Architectural Review Board Staff Report

Project Type:	Amended Site Development Section Plan
Meeting Date:	November 14, 2019
From:	Mike Knight, Assistant City Planner <i>mk</i>
Location:	A 7.3 acre tract of land located northeast of the intersection of Wild Horse Creek Road and Old Chesterfield Road.
Description:	<u>Downtown Chesterfield Category C, Lot A (WILDHORSE) ASDSP:</u> An Amended Site Development Section Plan, Landscape Plan, Lighting Plan, Architectural Elevations and Architect's Statement of Design for a 7.3 acre tract of land located northeast of the intersection of Wild Horse Creek Road and Old Chesterfield Road.

Staff requests review and recommendation on this submittal for Downtown Chesterfield Category C, Lot A (WILDHORSE) Amended Site Development Section Plan.

SOUTH ELEVATION

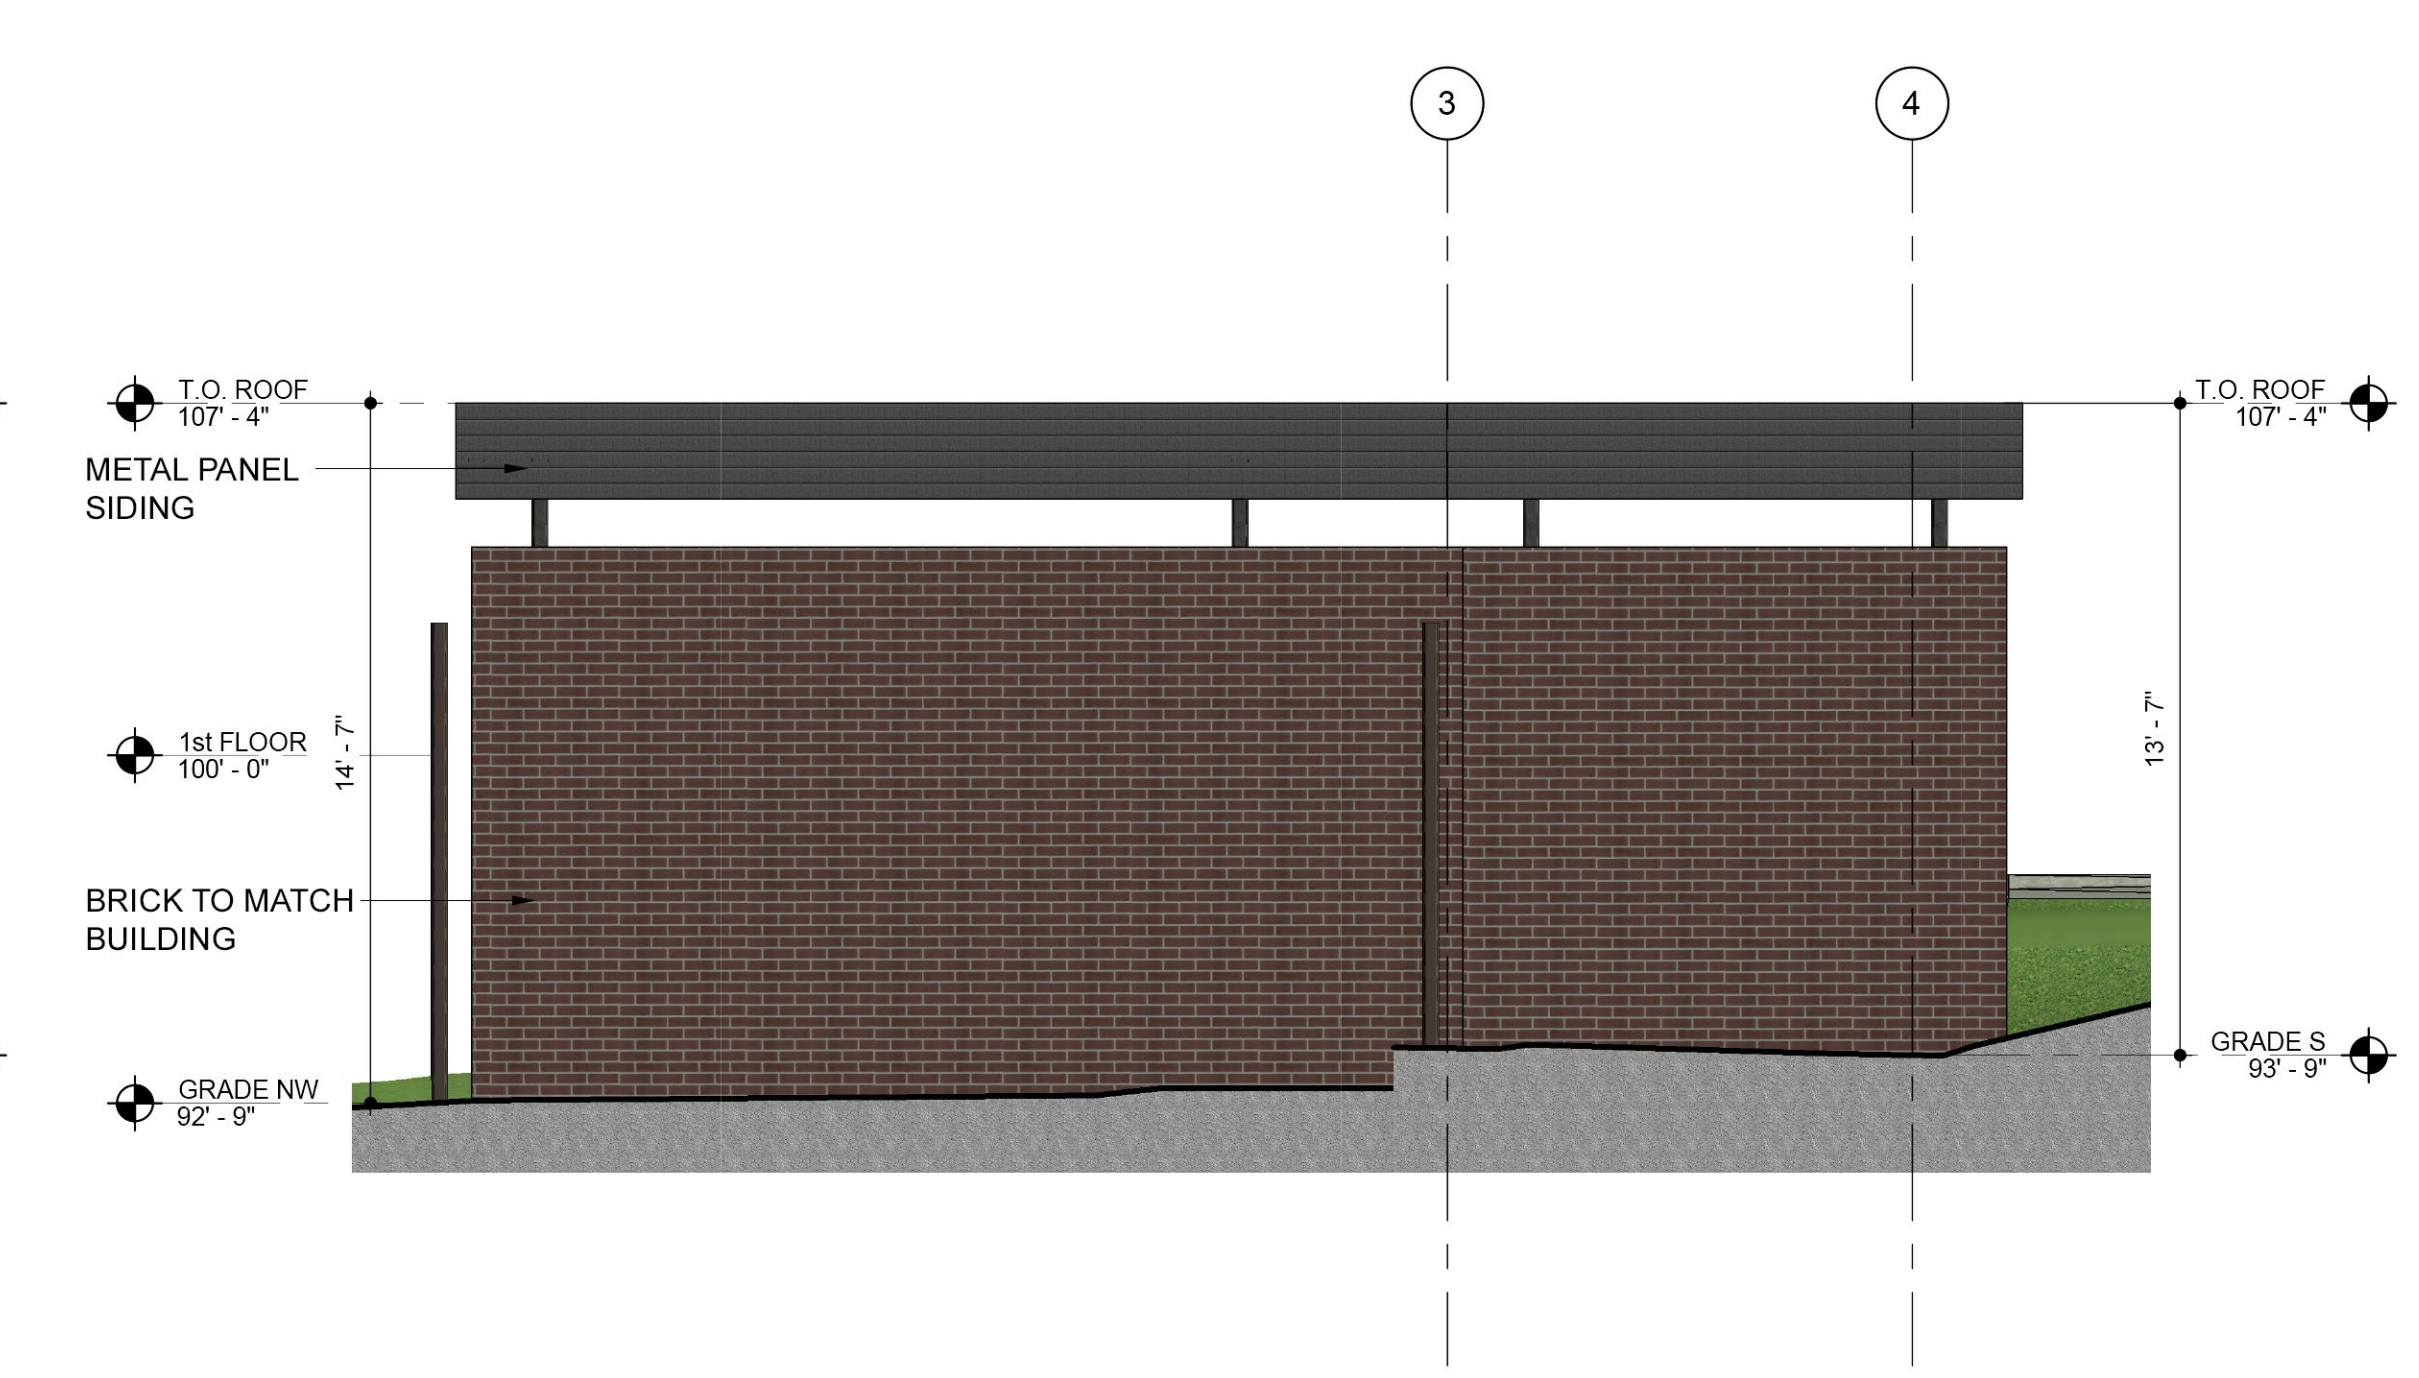
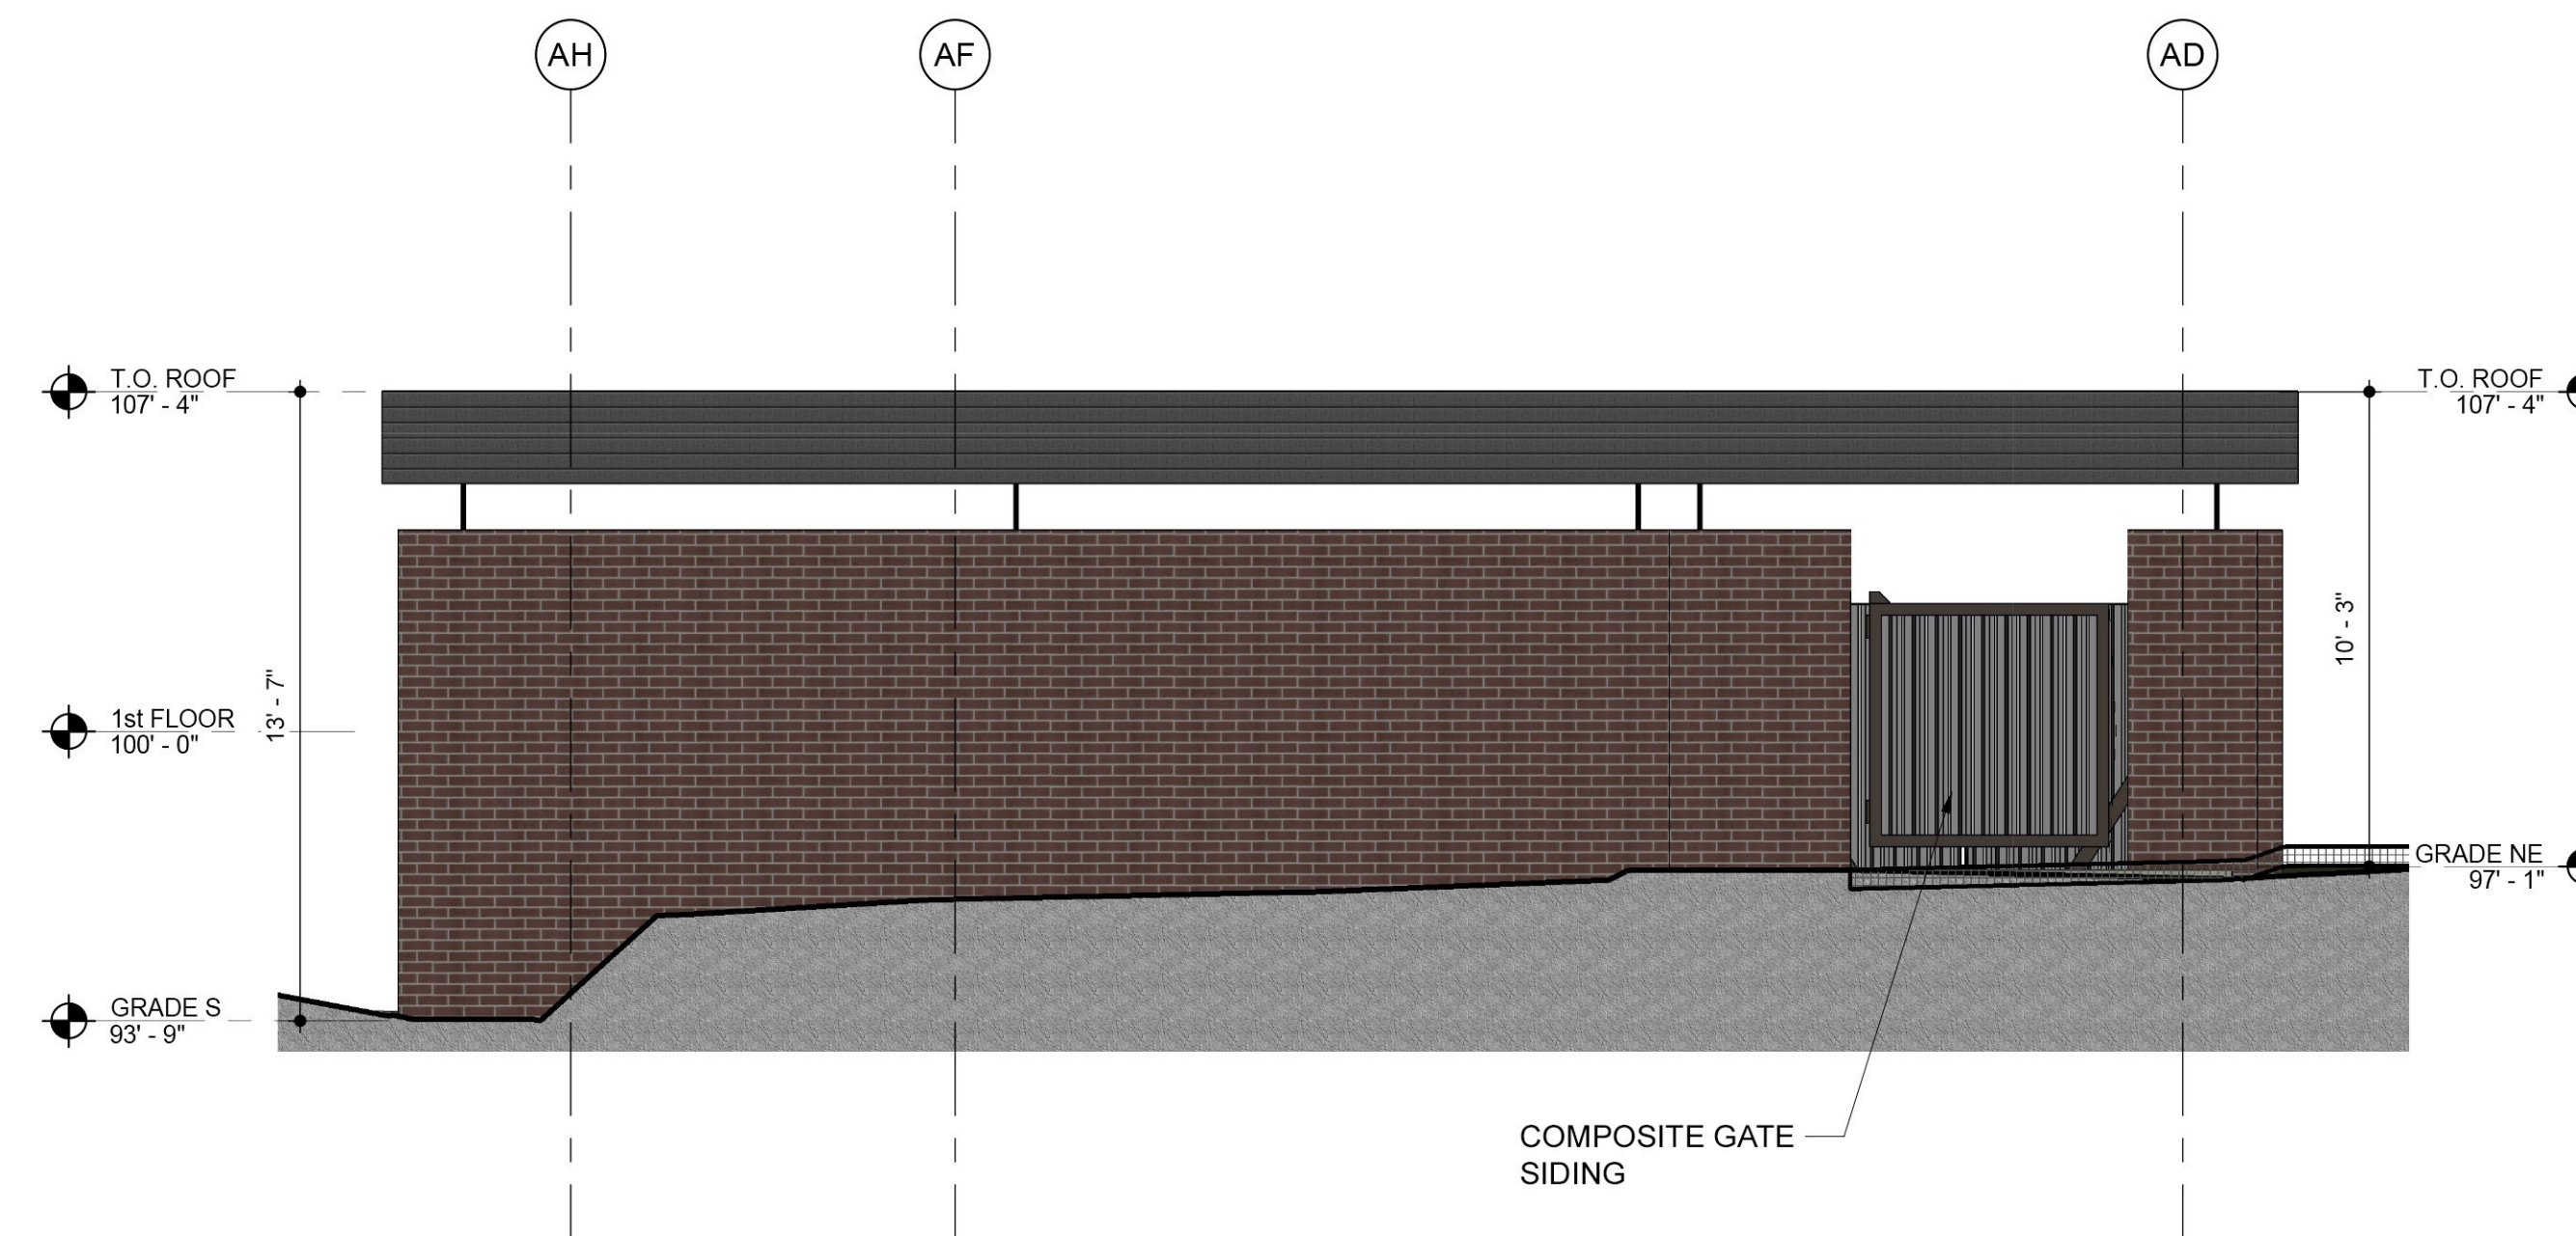
The footprint of the trash enclosure is largely the same. There are two main differences being proposed (Figure 4). The first is an additional metal panel on the top of the structure that is a similar feature to the metal panel located above the restaurant. The second is that the overall height of the enclosure is larger. The currently approved trash enclosure is 6' tall, while the new enclosure is roughly 14' tall including the metal feature depending on the grade change.

1. Openings in the north and west elevations of the garage have been revised to 1" insulated glass in aluminum storefront system, in lieu of, the previously approved fence material.
2. Metal louvers have been introduced on the north and west elevations of the garage. The intent is to paint the louvers to match the adjacent building material.
